A303 Sparkford to Ilchester Dualling Scheme TR010036

8.3 Draft Statement of Common Ground with Historic England

DRAFT STATEMENT OF COMMON GROUND

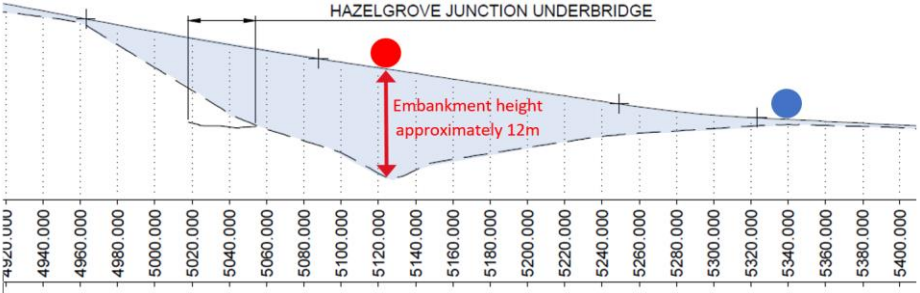
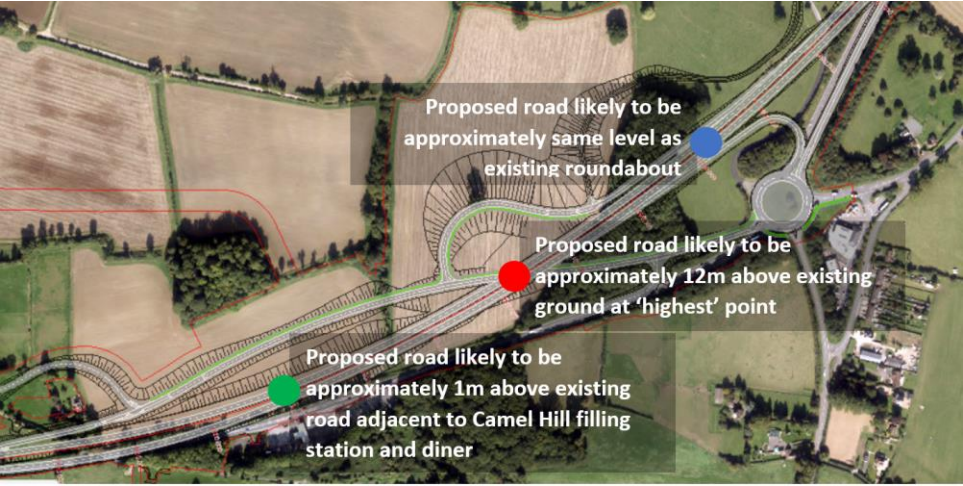
<p>CS provided an overview of the anticipated heights of the new junction layout at Hazlegrove RPG, using the below images to aid the discussion.</p> <p>SM asked to see cross sections to show the slope profiles from the Hazlegrove House key view. CS confirmed that the design team could develop these and issue for information shortly.</p>	CS / OM to develop
